## BUILDING CONSTRUCTION PERMIT

Permit Number: 040696

This is to certify that Dewis Karen / Monaghan Construction, Inc.  
has permission to 3300" sq ft finished single family home with a separate 1165" sq ft detached seasonal storage space  
AT 51 Spring Cove Ln 083E A024001

project: **Dewis Molyneux Cottage**, Great Diamond Island, Maine

**TITLE:**  
 LIMITED EXISTING CONDITIONS SURVEY  
 DIAMOND COVE PHASE II LOT 24  
 GREAT DIAMOND ISLAND  
 CITY OF PORTLAND CUMBERLAND COUNTY  
 STATE OF MAINE

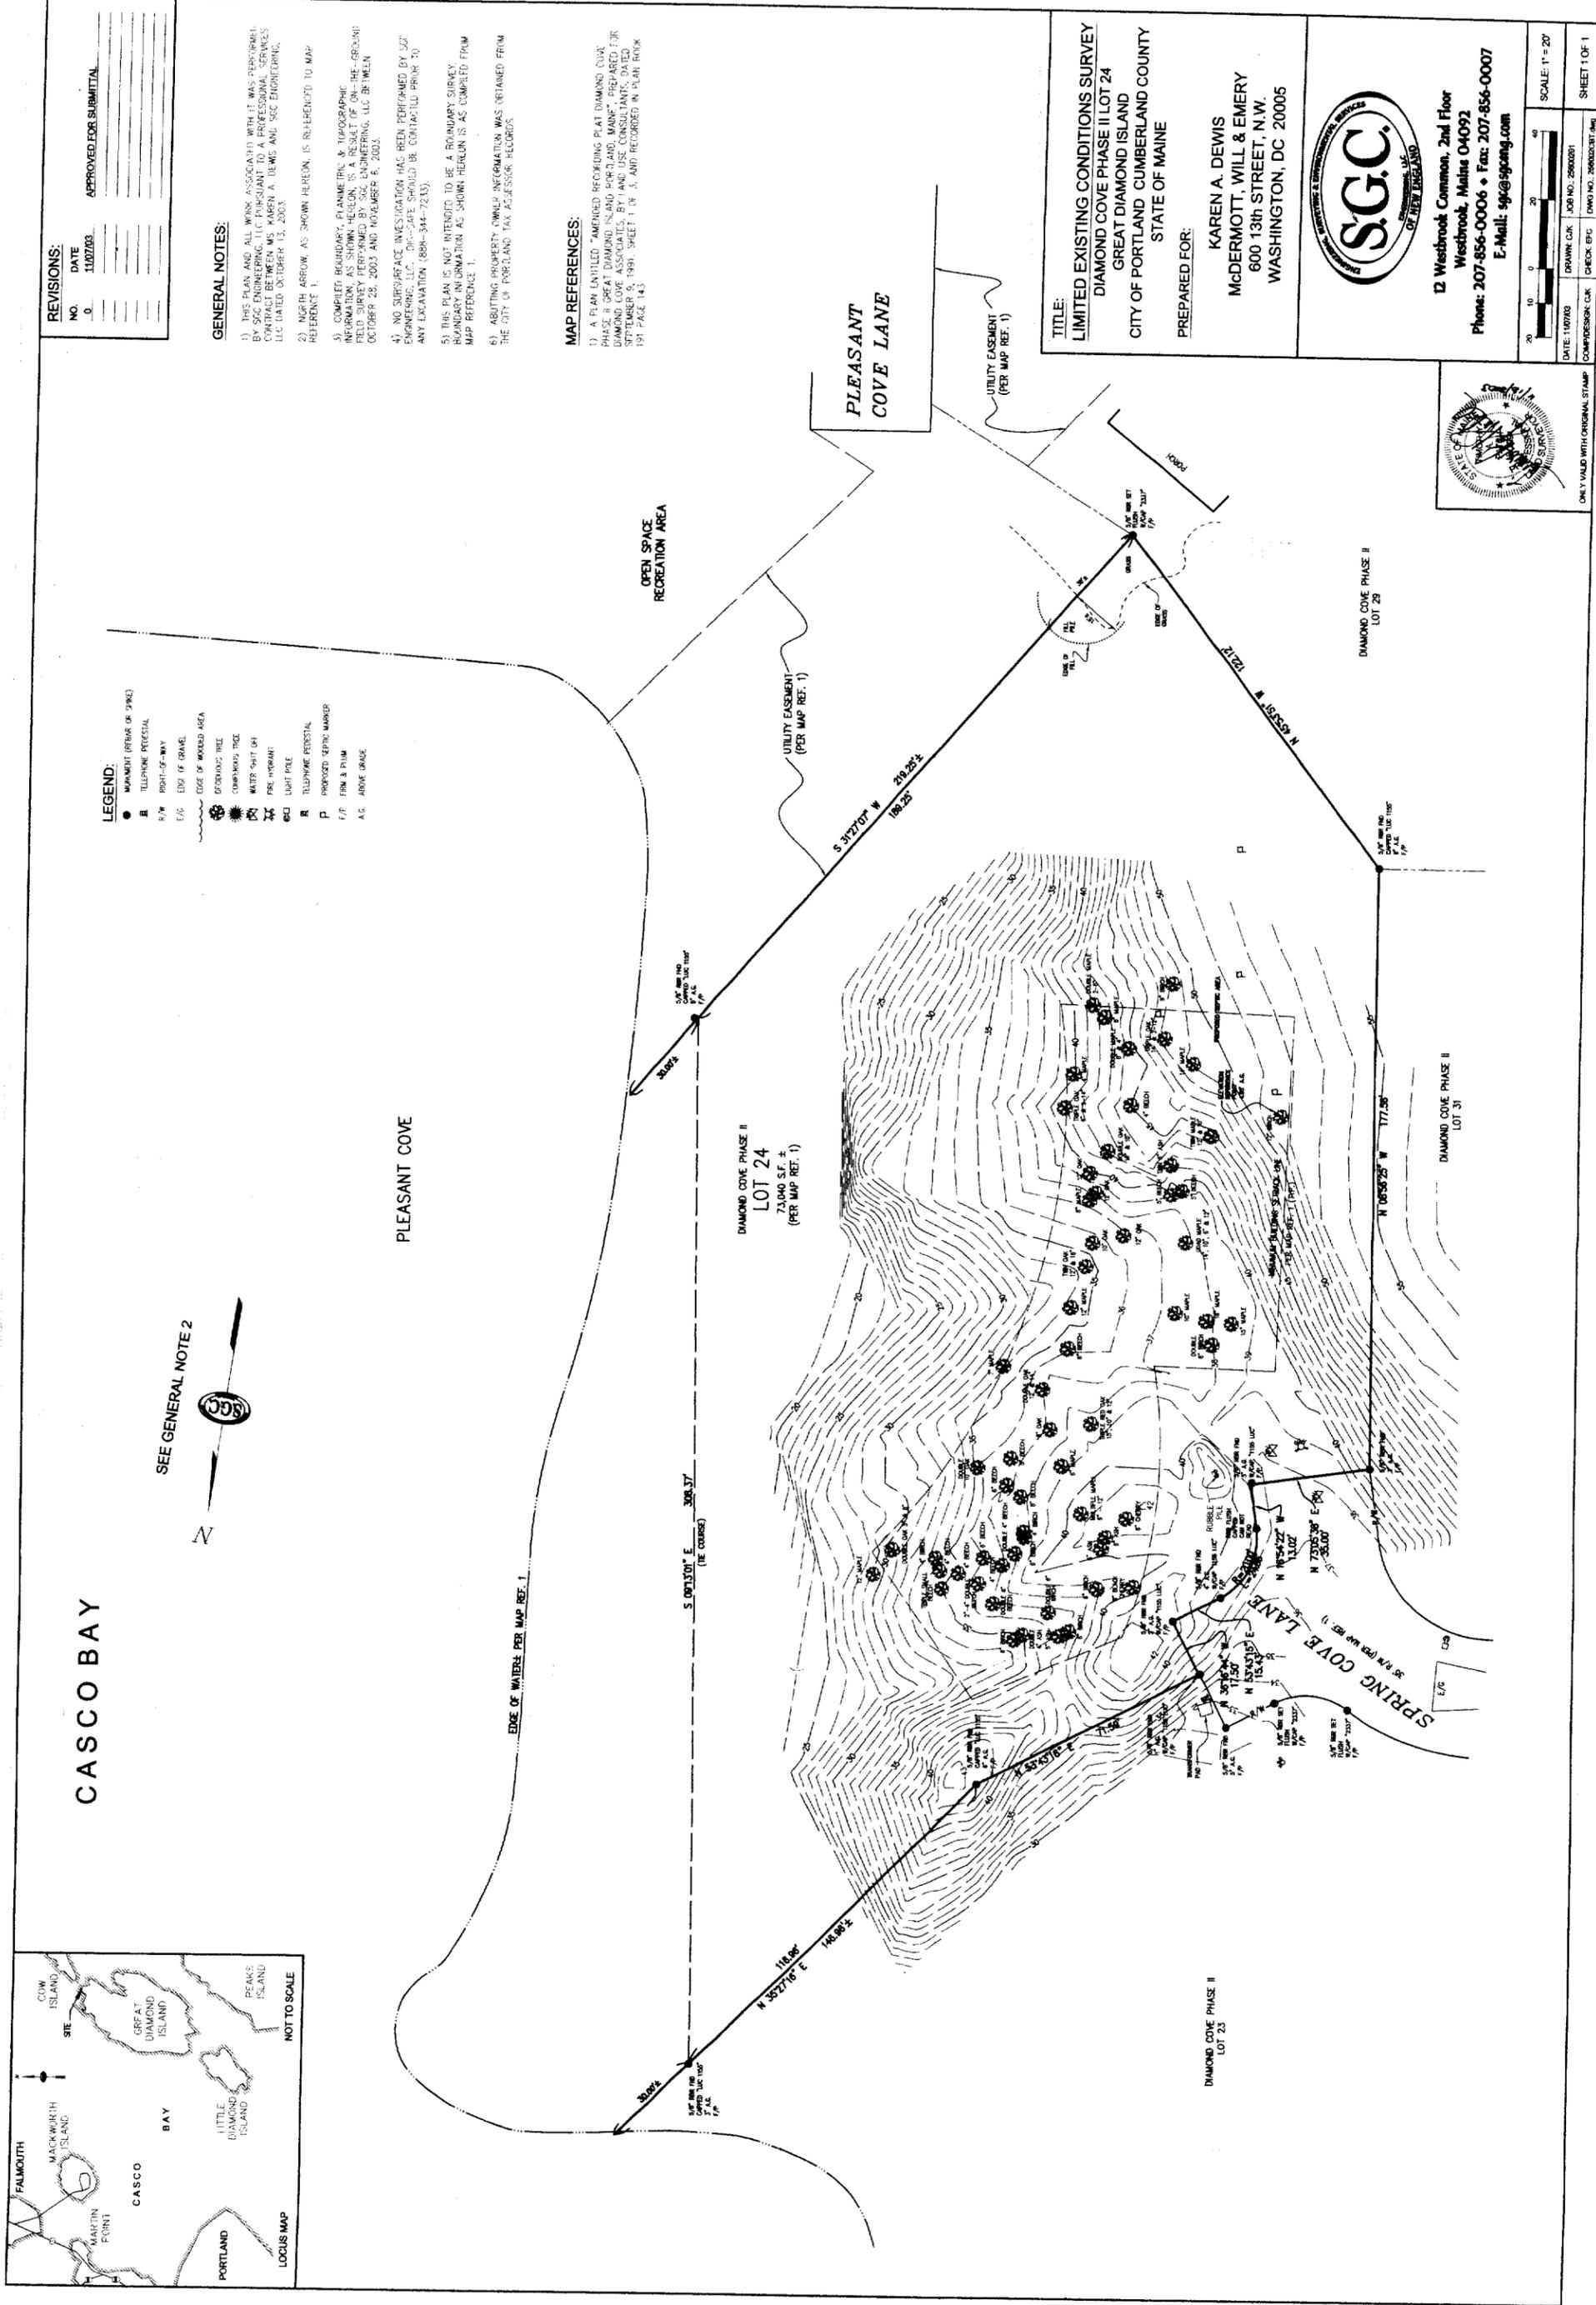
**Dept:** Zoning      **Status:** Approved with Conditions      **Reviewer:** Marge Schmuckal      **Approval Date:** 06/29/2004  
**Note:** 6/25/04 requested site plan with the 75' from the HWM from Rob Whitten - That is not denoted on the submitted plans      **Ok to Issue:**   
6/28/04 - received plans showing the 75' setback from HWM

- THANKS FOR YOUR CALL. THE ENCLOSED SITE PLAN HAS ADDED INFORMATION SHOWING THE 75' SHORELAND SETBACK FROM HIGH TIDE LINE AS DETERMINED BY S.G.C.

- PLEASE NOTE THAT THE CLOSEST PORTION OF THE PROPOSED STRUCTURE IS AN ADDITIONAL 37' SETBACK FROM THE 75' LIMIT.
